HISTORICAL SITE ASSESSMENT

**FOR THE FOREST GLEN ANNEX OF
WALTER REED ARMY MEDICAL CENTER, SILVER SPRING, MD
AND THE LEASED
GILLETTE BUILDING AND TAFT BUILDING, ROCKVILLE, MD**

**Radiological HSA
Draft Report Comments
WRAMC Forest Glen Annex**

FIGURE 5-5: CONCEPTUAL SITE MODEL (CSM) FOR WRAMC

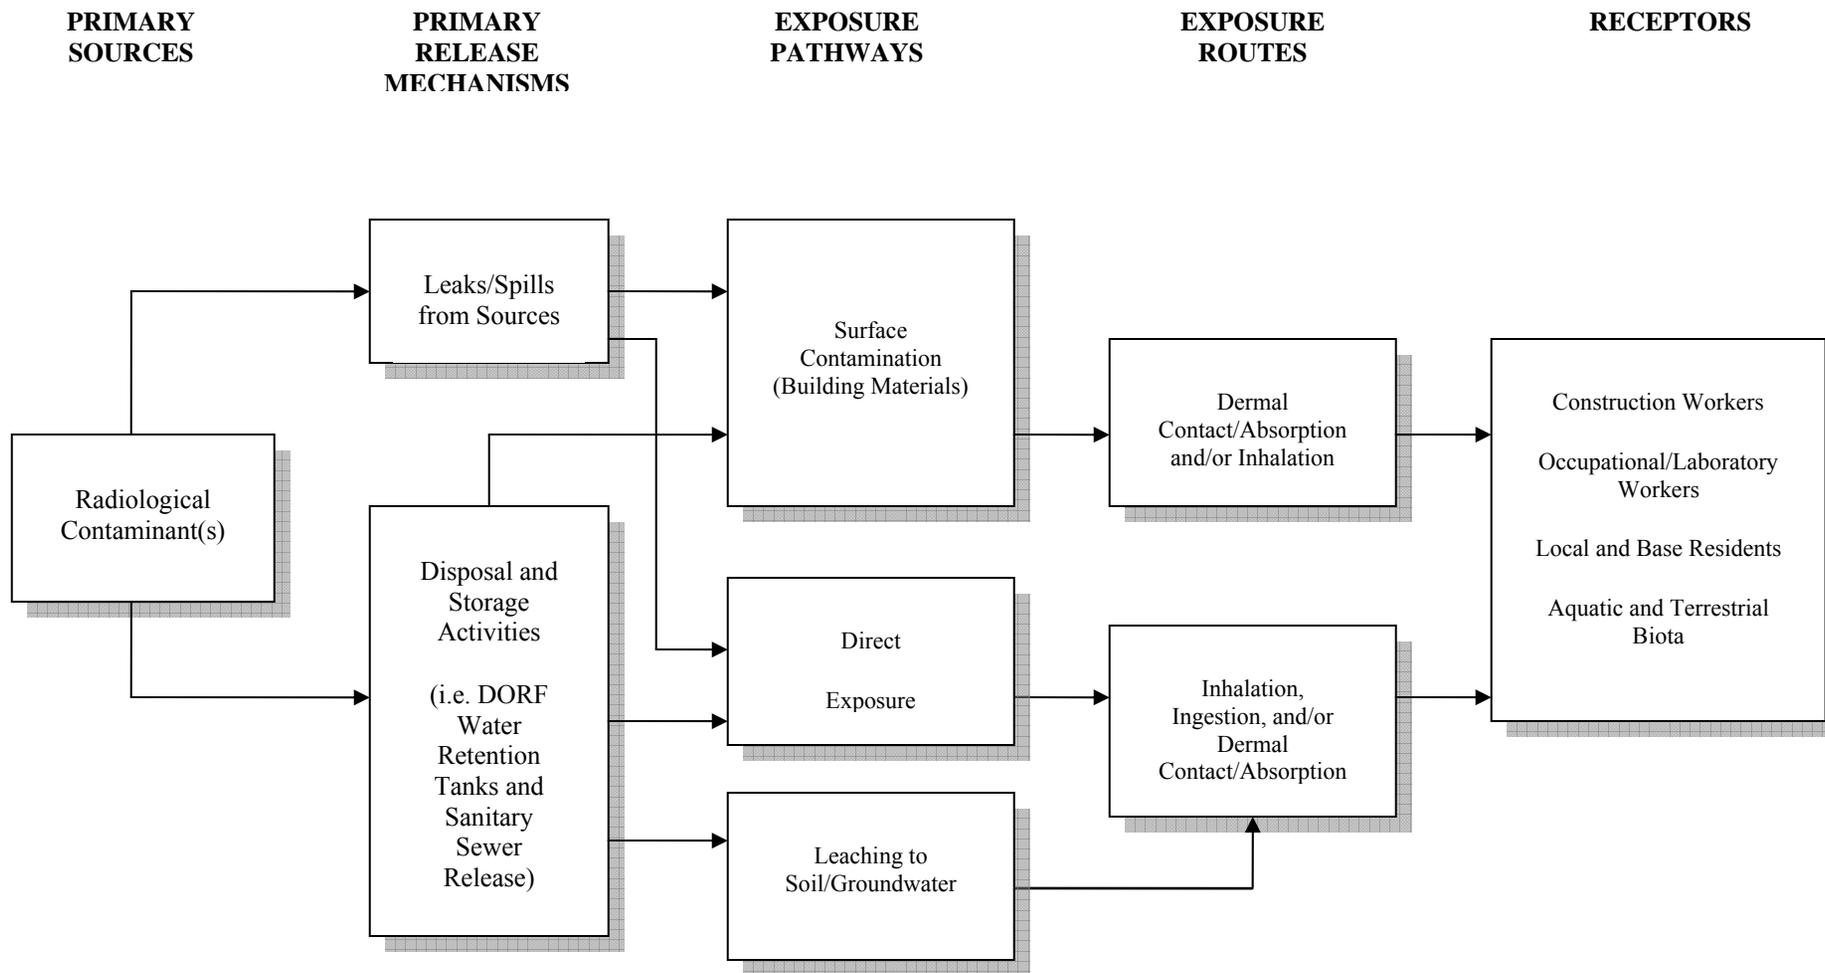
Comment Number	Page Number	Section/Figure/ Table/Appendix	Commentor- ORG	Comment	Response By	Response
16	5-20	Fig 5-5	Barbour- USACE HP	Where does sewer discharge and outdoor areas fit into this CSM figure?	Cabrera	No outdoor areas other than the water retention tank area near Building 516 (DORF) would pose a potential cause for concern. The figure has been revised to incorporate this tank area and sewer discharge into the box for Disposal and Storage Activities.
17	7-5	Table 7-1	Barbour- USACE HP	Please revisit all of the N/Ls on Table 7-1 and find some alternative approaches. This just looks terrible and leaves one thinking, OK, then what do I use?!	Cabrera	Concur. The table has been re-done to only provide values for the isotope in its primary decay mode (thus, eliminating the N/L values for alpha, being that most of these isotopes are beta emitters). Also, values from NUREG/CR-5512 have been used to supplement the table where necessary. For the few isotopes remaining where no values is listed, a note has been made to the effect of these isotopes are all very short-lived, and would likely be decayed away to negligible levels between the time they are removed and the time any scoping survey would occur.
